Network Clothing Ltd. Network Apparel Ltd.

Observations

Problems Observed in Building 1

Overloaded storage areas

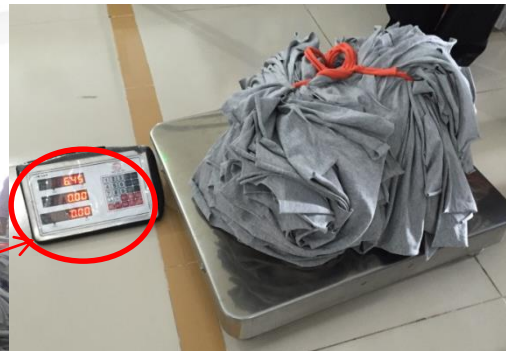
Load was observed almost double from the load plan

Each bundle was measured to be 6.45 kg

Each roll was measured to be 21 kg

Item No.	Observation	Recommended Action Plan	Recommended Timeline
1	Overloaded storage areas	The quantity of the stored materials (piles of cloth and packages) must be reduced to the level presented by the original designer in the Loads Plans	6-weeks
2	Overloaded storage areas	Reduce loading to the recommendations of the loading plan	6-months
3	Cracks in the beams and slabs at upper levels	Building Engineer to investigate all cracks and check the static calculations for thermal effects at the upper levels	6-weeks
4	Cracks in the beams and slabs at upper levels	Repair cracking following the above investigation	6-months
5	Lack of movement joint	Building Engineer to check the static calculations for thermal and shrinkage effect of the 100m long structure system.	6-weeks

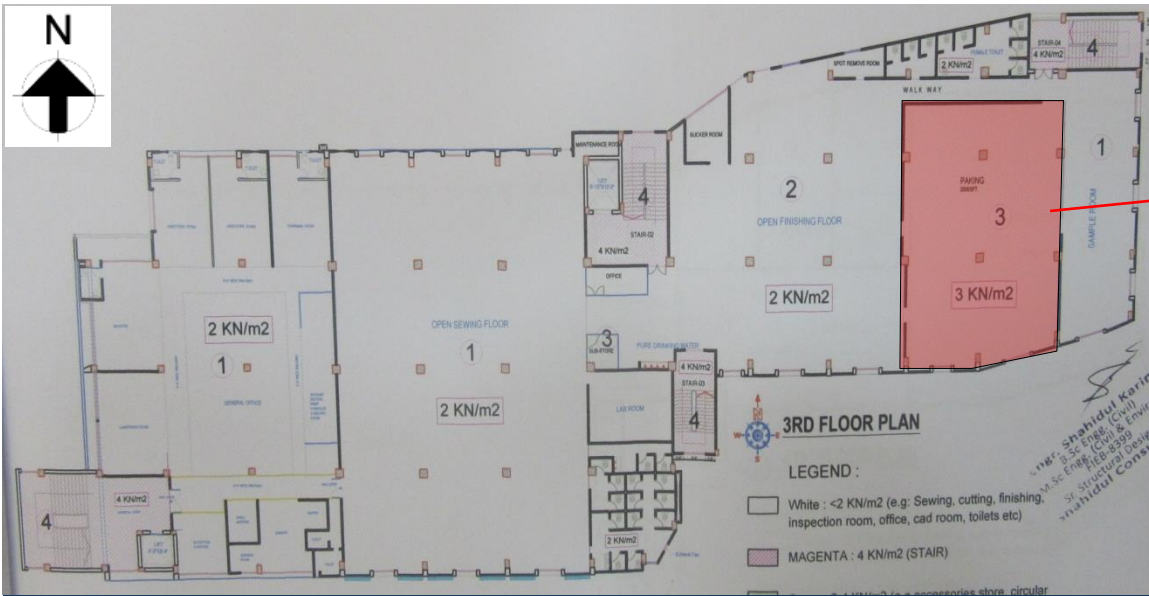
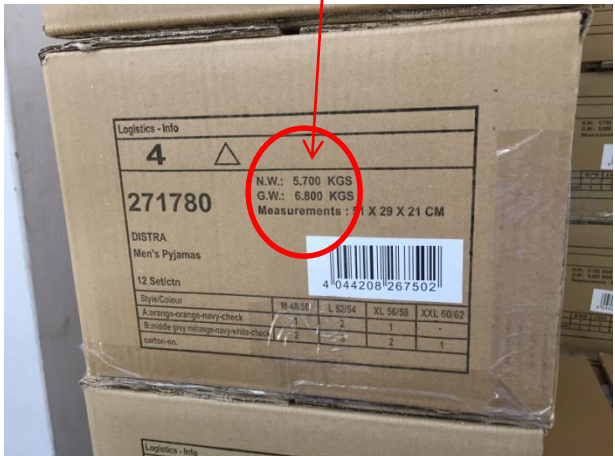
Load was observed to be almost double that indicated on the load plan

Each box was indicated to be 6.8 kg

Cracks in the beams and slabs at upper levels

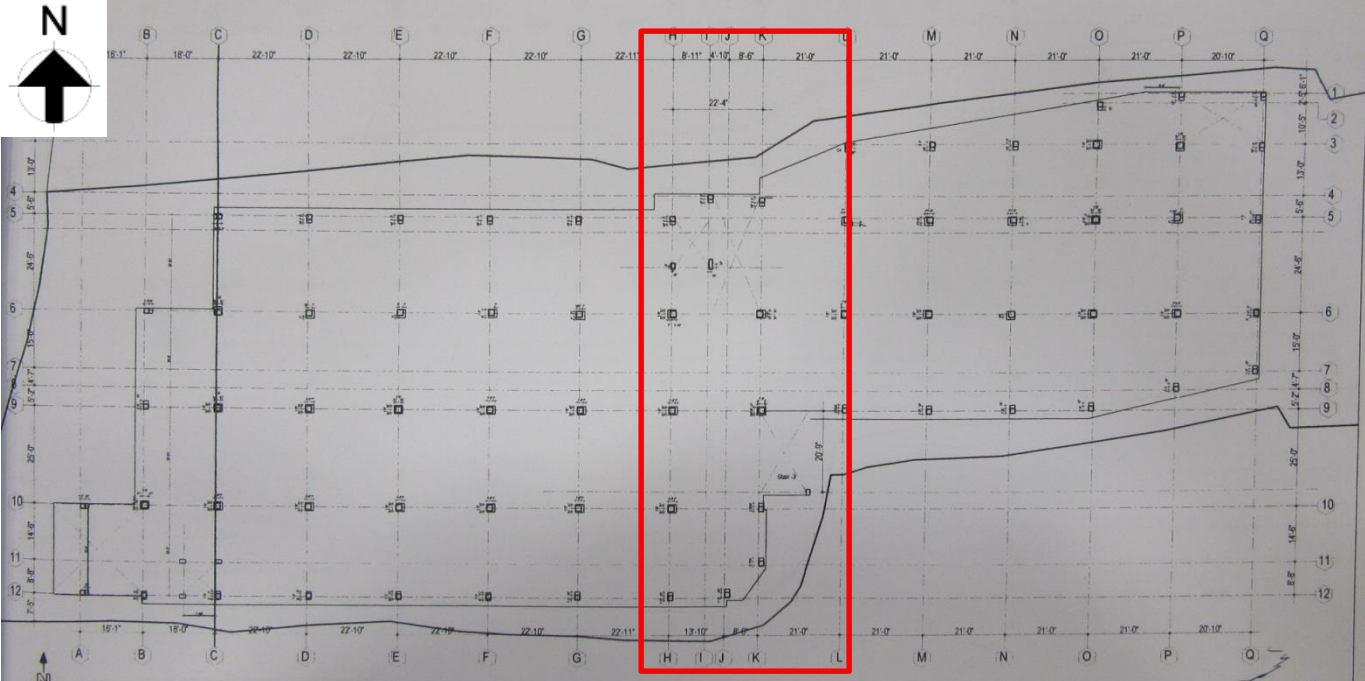
One of them was exposed during survey and found it was on concrete

At 3rd to 5th floor many cracks were visible on beams and slabs
